UNITED STATES PATENT AND TRADEMARK OFFICE

APPLICATION NO.	FILING DATE	FIRST NAMED INVENTOR	ATTORNEY DOCKET NO.	CONFIRMATION NO.
09/748,277	12/27/2000	Jae-Lag Ma	8733.363.00	4729

Office Action Summary

DETAILED ACTION

Fig. 1
(Conventional Art)

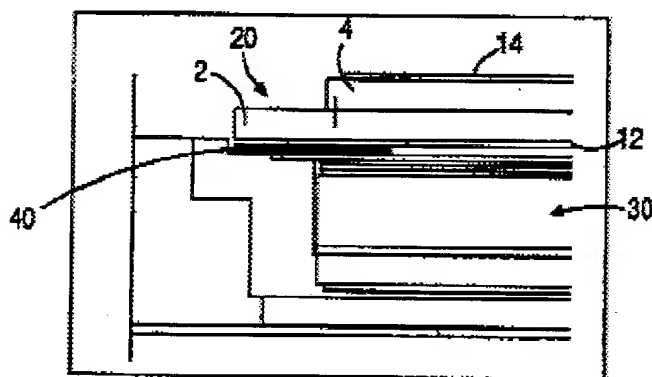
As to claims 6 and 9-12, APA discloses in Figures 1-4 (Specification pages 2-4), a dot matrix (Specification, Page 2, lines 18-22) liquid crystal display (LCD) device, comprising:

an upper polarizer, 14; on an upper substrate, 4;
a lower substrate, 4, on a lower polarizer, 12;
a liquid crystal layer (not shown) disposed between the upper substrate and the lower substrate; and

a backlight device, 30, disposed opposite and adjacent to the lower polarizer for emitting light toward the lower polarizer (Figure 1) (please note that adjacent does not preclude structures between those items considered to be adjacent, e.g., two houses may be adjacent despite the existence of an intervening garage); wherein at least a black pad, 40, that acts as a light shield (Applicant's light shielding film) only along a peripheral portion (Specification, Page 3, lines 11-14); and wherein the light shielding film absorbs light (property of the color black).

APA does not explicitly disclose a lower polarizer that includes said light shielding film.
